HISTORIC PRESERVATION ADVISORY COMMITTEE AGENDA Community Development Building – 51 Winburn Way <u>February 8, 2023, 5 - 7PM</u>

HISTORIC PRESERVATION ADVISORY COMMITTEE MEETING DRAFT (Action) Meeting Minutes December 7, 2022

(6:35) PLANNING ACTION REVIEW (20 min) PLANNING ACTION: PA-T1-2022-00199 SUBJECT PROPERTY: 748 Siskiyou Blvd

KEYNOTES NEW GABLE TRIM NEW PERGOLA DEMO EXISTING OVERHANG

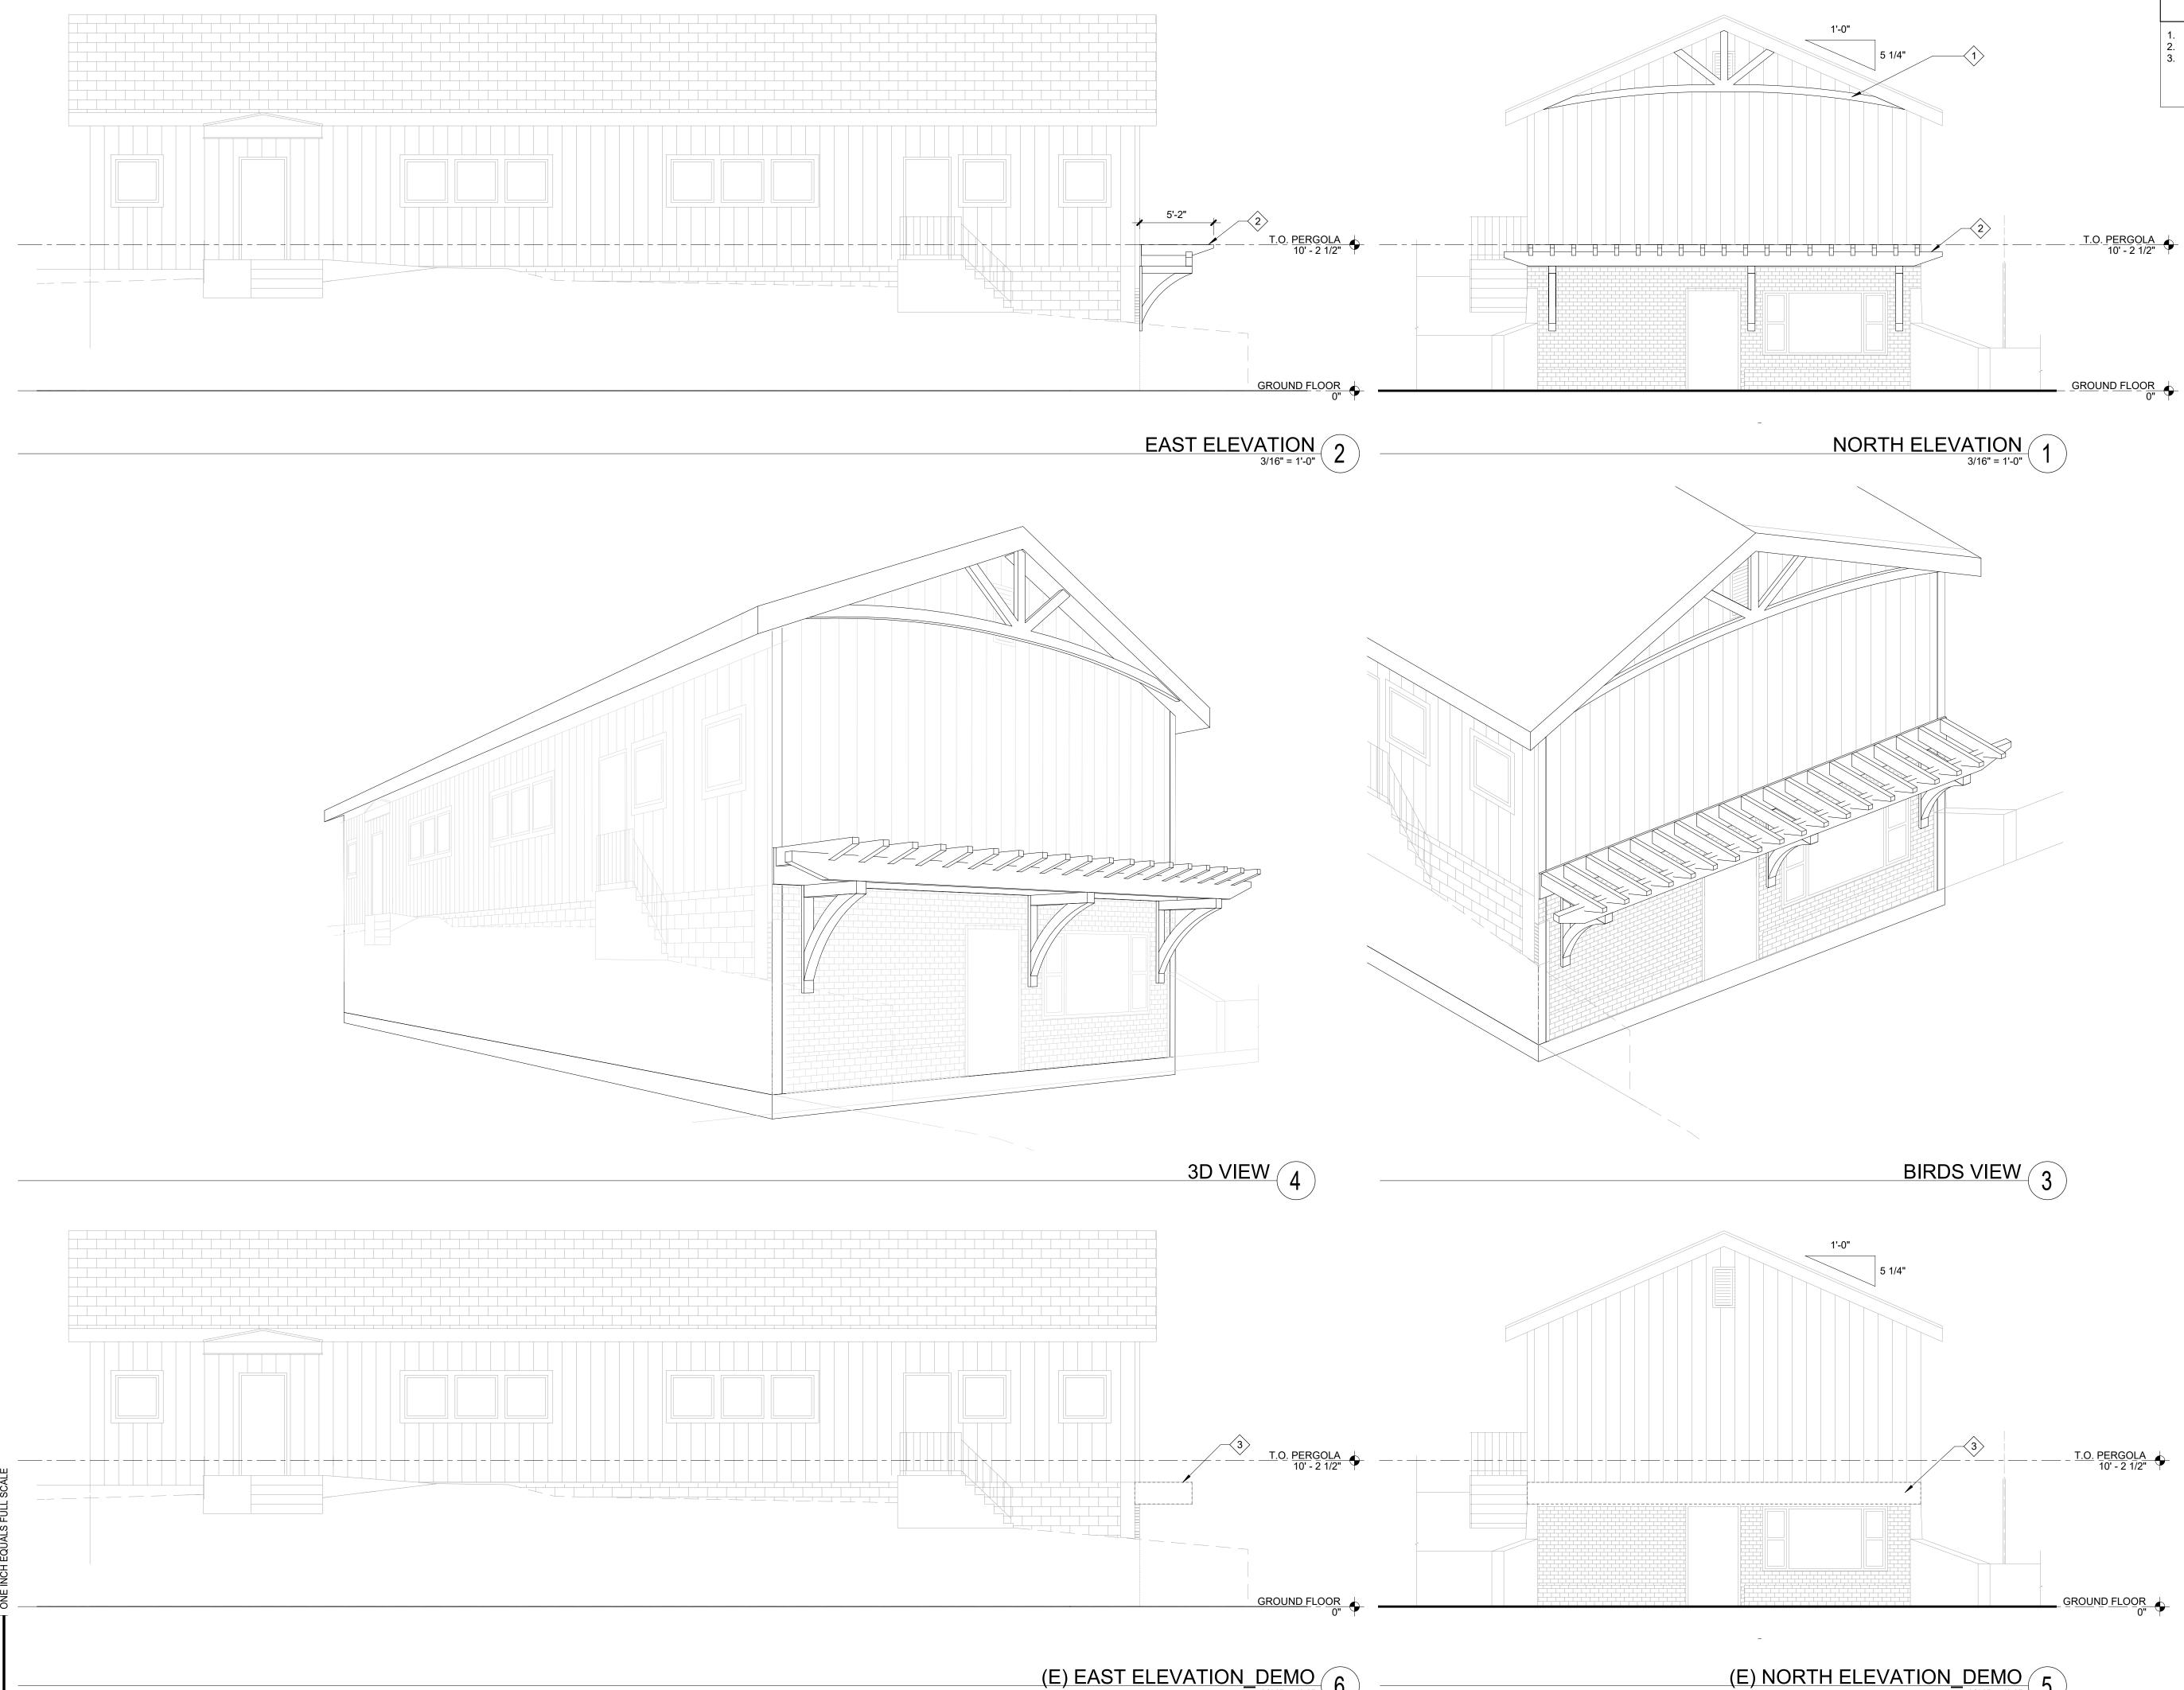
Commissioners discussed potential design changes which might better address compatibility with Historic District Development Standards including reducing the scale/size of structural members of the pergola, adding windows to the Siskiyou Boulevard-facing wall above the pergola, and retaining the existing four knee braces either in combination with or in lieu of the proposed new arched gable element.

Entry Door: The proposed entry door facing Siskiyou Blvd. is called out as a storefront door but does not specify what that is exactly. If what is proposed is metal storefront with narrow metal styles and rails, a modern commercial look, I would suggest a full light wood door, or one that matches main entry which is a small pane true divided lite wood door, both would be more compatible to the neighborhood and just as functional. It would also be more consistent with the very attractive proposed wood beam pergola and gable end in treatment details.

Windows: I would recommend the addition of a bank windows on the second story facade above the pergola on Siskiyou Blvd. to help mitigate the very tall and blank vertically wood sided wall. They could be proportional to the two square windows found around the corner on the east facing wall. Maybe, three equally spaced square windows centered on the gable end. Building Permit Review: Paddington Station. 125 East Main

Ultimately, the Commission recommended that the design be approved as presented and advised the applicant to consider the addition of three windows in the wall face above the pergola.

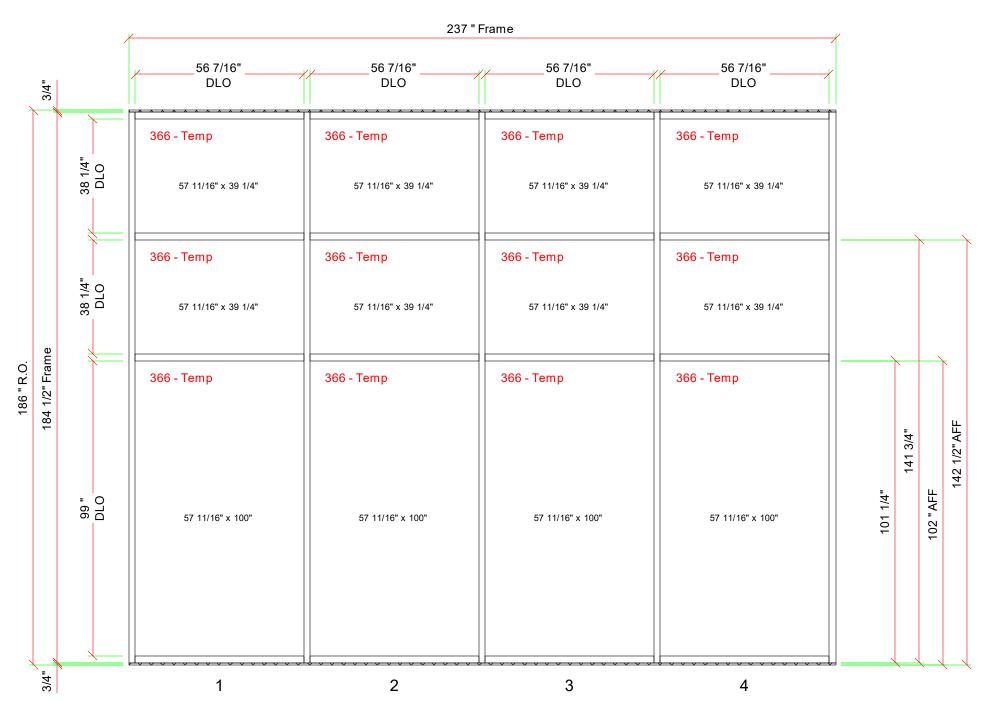
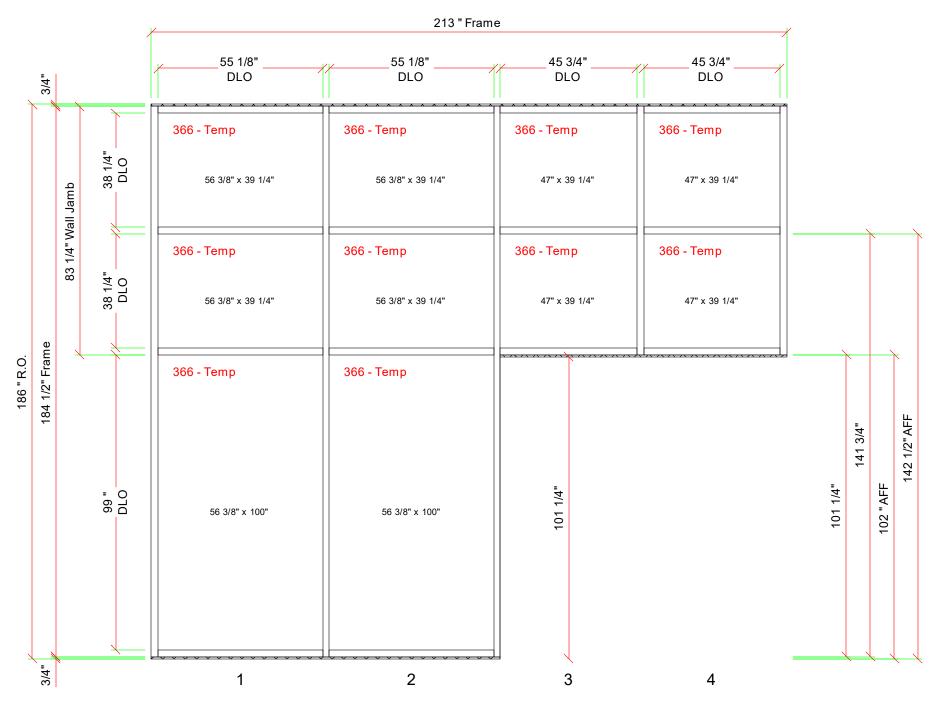
Last week I met at Paddington Station with Kyle Taylor, Taylor Elements Construction, to discuss the details of the owners' proposal for a total replacement of the two-story historic storefront display windows at the street entrance. Kyle explained that the owners were concerned about energy heat loss from the existing single pane glass, and if replaced, would also add a safety factor with the addition of tempered glass.

The proposal for the window replacement would affective remove all the historic window glazing, the wood sash support, and the original half-round sheet metal cladding and trim. The two-story high glazing area is approx. 15 ft. high and 36 ft. wide except for the recessed double entry doors. Additionally, the proposal calls for reducing the three, 10 ft. wide display picture windows, into six, 5 ft. wide display windows.

Historically, storefront display windows were kept as wide as possible to provide the best visibility for the merchandise and is a common pattern found in the downtown. The storefront windows in the Paddington Station building are particularly notable because they are the largest original storefront windows in our Downtown Historic District.

If this project were a Planning Action (and it is not), the Historic Commissions requirements would include detail scaled drawings at $1\frac{1}{2}$ " = 1 ft. to ensure compatibility with the remaining historic components. Those would include detailed sections of the window sills, all jamb conditions, heads, and trim. Additionally, I would suggest that all the new materials including the aluminum and wood parts be painted to match as is the case now, which would hide and mitigate the impact of these modern aluminum materials.
